Mecklenburg County
Health Department

Re: 6900 Mt. Holly-Huntersville Road
File: 999A
Parcel: 033-111-01

SOIL/SITE EVALUATION for ON-SITE WASTEWATER SYSTEM

#3 999A
033-111-01

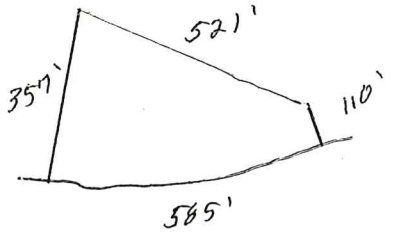
PROFILE #	Slopes 5-12% .1940 LANDSCAPE POSITION/ SLOPE %	HORIZON DEPTH (IN.)	SOIL MORPHOLOGY (.1941) .1941 STRUCTURE/ TEXTURE	SOIL MORPHOLOGY (.1941) .1941 CONSISTENCE/ MINERALOGY	OTHER PROFILE FACTORS .1942 SOIL WETNESS/ COLOR	OTHER PROFILE FACTORS .1943 SOIL DEPTH	OTHER PROFILE FACTORS .1956 SAPRO CLASS	OTHER PROFILE FACTORS .1944 RESTR HORIZ	PROFILE CLASS & LTAR
1	R	0-6"	gr/scl	Fr/SEXP/SS/SP	31" ~~60~~" TO soil wetness	31"	US scl VFi	N/A	~~Abov~~ US
		6-31"	SBK/sc	Fi-VFi/EXP/US/UP					
		31-60"	massive scl	VFi/SEXP/SS/SP					
2	LS	0-27"	gr/scl	Fr/SEXP/SS/SP	2.5Y 7/1 @ 27"	41"	US scl VFi	N/A	~~Abov~~ US
		27-41"	ABK/SBK/sc	Fi/EXP/US/UP					
		41-51"	Massive/scl	VFi/SEXP/SS/SP					
3	LS	0-14"	gr/sl	Fr/SEXP/NS/UP	2.5Y 6/2 @ 20"	58"	US scl VFi	N/A	US
		14-31"	SBK/scl	Fr/SEXP/SS/SP					
		31-58"	SBK/ABK/c	VFi/EXP/US/UP					
		58"+	massive/scl	VFi/SEXP/SS/SP					
4	LS	0-11"	gr/sl	Fr/SEXP/NS/UP	2.5Y 7/1 @ 16"	~~60~~ 43"	US scl VFi	N/A	US

11-18"	SBK/scl	Fr/SEXP/SS/SP					
		18-32"	SBK/ABK/sc	VFi/EXP/US/UP					
		32-43"	massive/scl	VFi/SEXP/SS/SP

OTHER FACTORS (.1946): _____
SITE CLASSIFICATION (.1948): Unsuitable
EVALUATED BY: W.A. Martin 7-8-97
OTHER(S) PRESENT: LSS

3
999A
033-111-01

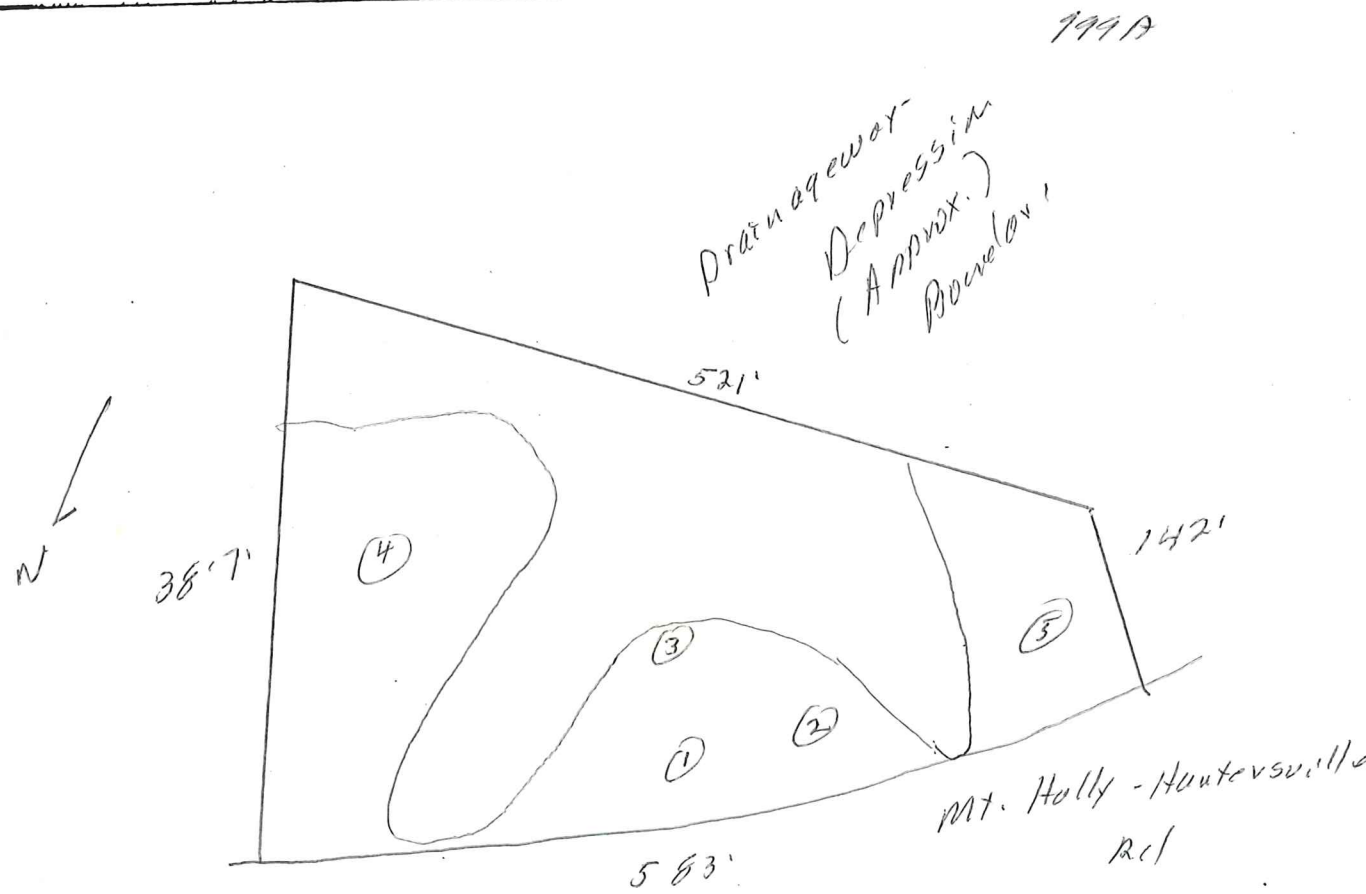
PROFILE #	3/m-s 5-10% .1940 LANDSCAPE POSITION/ SLOPE %	HORIZON DEPTH (IN.)	SOIL MORPHOLOGY (.1941) .1941 STRUCTURE/ TEXTURE	.1941 CONSISTENCE/ MINERALOGY	OTHER PROFILE FACTORS .1942 SOIL WETNESS/ COLOR	.1943 SOIL DEPTH	.1956 SAPRO CLASS	.1944 RESTR HORIZ	PROFILE CLASS & LTAR
1	LS	0-24"	sBK/ABK-sc	VFi/EXP/VS/VP	2.5Y 7/1 @ 11"	24"	N/A	None	US
2	FS	0-6"	gr/s/	Fr/SEXP/NS/NP	2.5Y 6/2 @ 24"	36"	N/A	None	US
		6-36"	sBK/sc/	Fr/SEXP/SS/SP					
3	LS	0-10"	gr/sc/	Fr/SEXP/SS/SP	2.5Y 7/1 @ 12"	19"	N/A	None	US
		10-19"	sBK/sc	VFi/EXP/VS/VP					
4	R	0-6"	gr/s/	Fr/SEXP/NS/NP	2.5Y 6/1 @ 12"	28"	N/A	None	US
		6-28"	sBK/sc	VFi/EXP/VS/VP					
5	LS	0-10"	gr/s/	Fr/SEXP/NS/NP	2.5Y 7/1 @ 15"	30"	N/A	None	US
		10-30"	sBK/sc	VFi/EXP/VS/VP

OTHER FACTORS (.1946):
SITE CLASSIFICATION (.1948): unsuitable
EVALUATED BY: W. A. Mullis 6-6-97
OTHER(S) PRESENT: LSS

@400 #3 999A 033-111-01

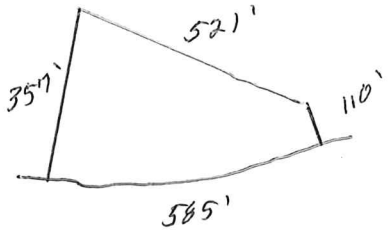
PROFILE #	.1940 LANDSCAPE POSITION/ SLOPE % (Slopes 5-12%)	HORIZON DEPTH (IN.)	SOIL MORPHOLOGY (.1941) STRUCTURE/ TEXTURE	SOIL MORPHOLOGY (.1941) CONSISTENCE/ MINERALOGY	OTHER PROFILE FACTORS .1942 SOIL WETNESS/ COLOR	.1943 SOIL DEPTH	.1956 SAPRO CLASS	.1944 RESTR HORIZ	PROFILE CLASS & LTA
1	R	0-6"	gr/scl	Fr/SEXP/SS/SP	31" 10YR 7/6 TO 5YR 5/1 wetness	31"	US scl VFi	N/A	~~Aqua~~ US
		6-31"	SBK/sc	Fi-VFi/EXP/US/UP					
		31-60"	Massive scl	VFi/SEXP/SS/SP					
2	LS	0-27"	gr/scl	Fr/SEXP/SS/SP	2.5Y 7/1 @ 27"	41"	US scl VFi	N/A	~~Aqua~~ US
		27-41"	ABK/SBK/sc	Fi/EXP/US/UP					
		41-51"	Massive/scl	VFi/SEXP/SS/SP					
3	LS	0-14"	gr/sl	Fr/SEXP/NS/UP	2.5Y 6/2 @ 20"	58"	US scl VFi	N/A	US
		14-31"	SBK/scl	Fr/SEXP/SS/SP					
		31-58"	SBK/ABK/c	vfi/EXP/US/UP					
		58"+	Massive/scl	VFi/SEXP/SS/SP					
4	LS	0-11"	gr/sl	Fr/SEXP/NS/UP	2.5Y 7/1 @ 16"	~~58"~~ 43"	US scl VFi	N/A	US
		11-18"	SBK/scl	Fr/SEXP/SS/SP					
		18-32"	SBK/ABK/sc	VFi/EXP/US/UP

32-43"	Massive/scl	VFi/SEXP/SS/SP

OTHER FACTORS (.1946):
SITE CLASSIFICATION (.1948): Unsuitable
EVALUATED BY: W.A. Marlin 7-8-97
OTHER(S) PRESENT: LSS
